**Amendments to the Drawings:**

## **REMARKS/ARGUMENTS**

In response to the Examiner's first Office Action of November 29, 2005 the Applicant respectfully submits the accompanying Terminal Disclaimer with respect to USSN 10/760,262, Amendment to the specification and claims, and the below Remarks.

FIG. 43

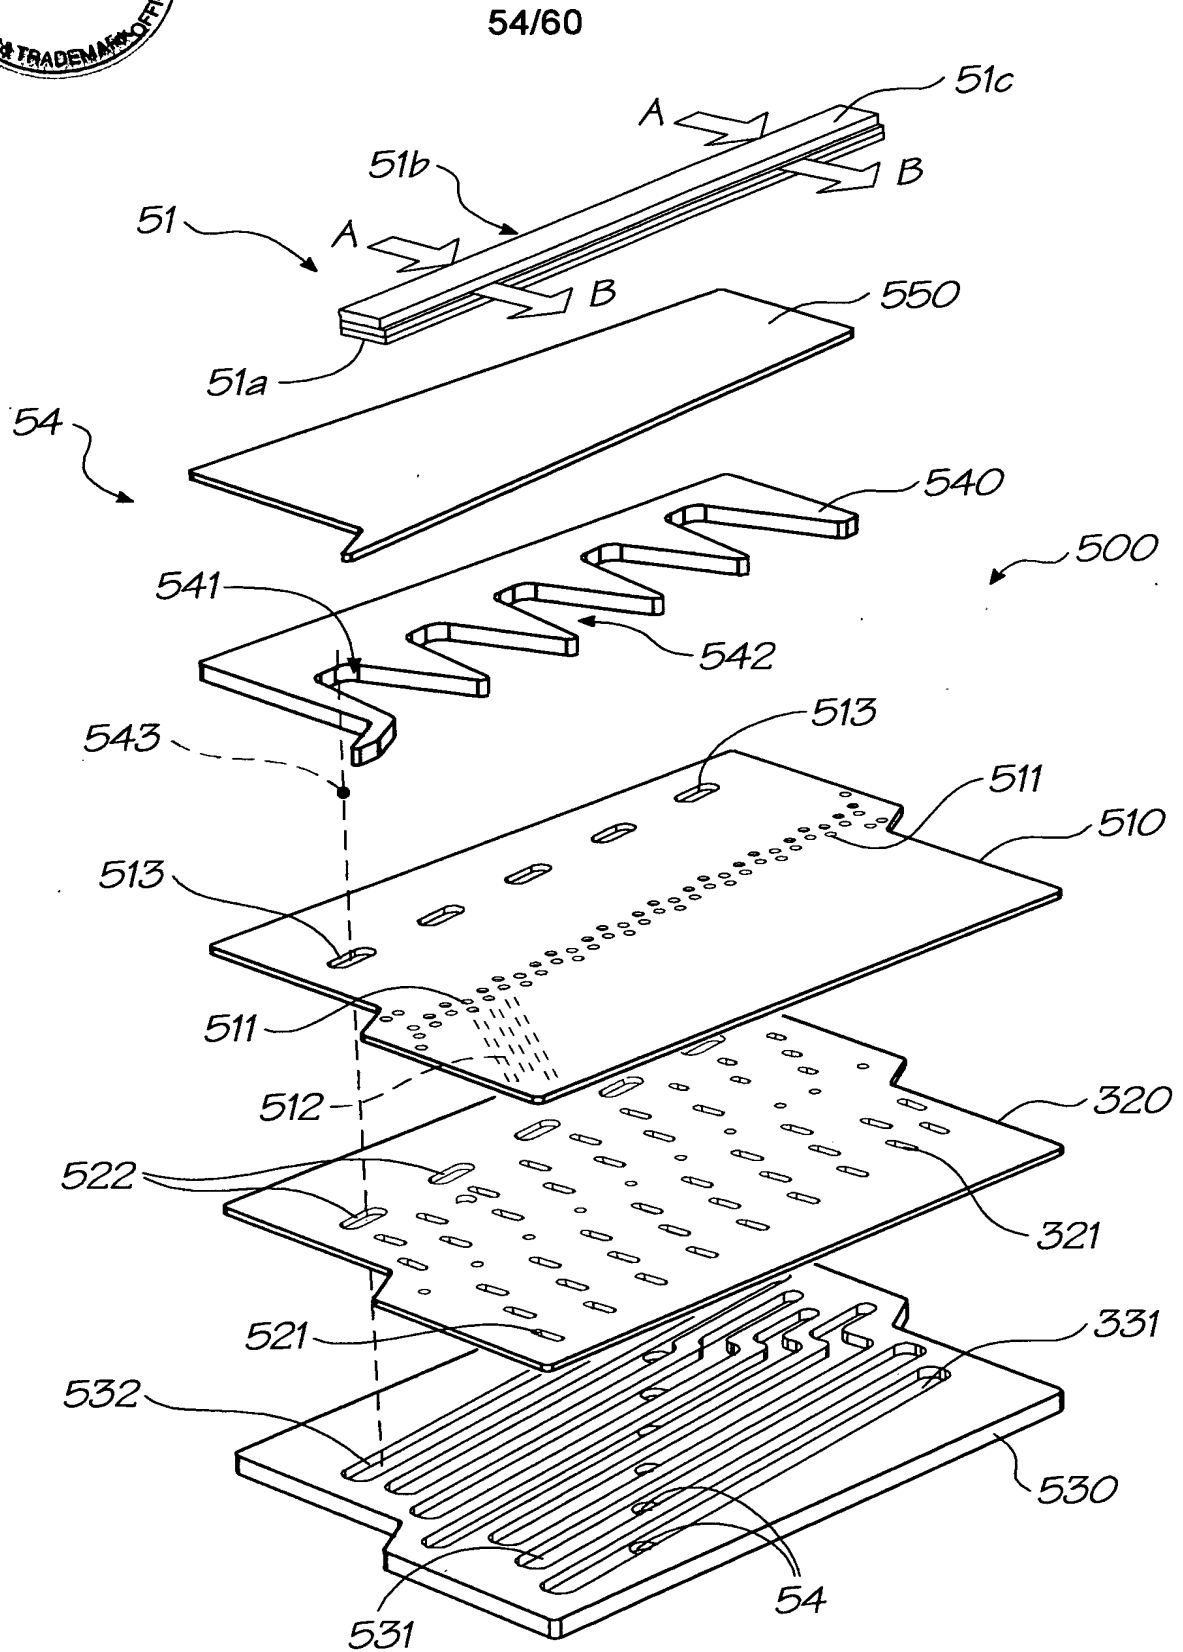
A corrected Fig. 43 is enclosed.
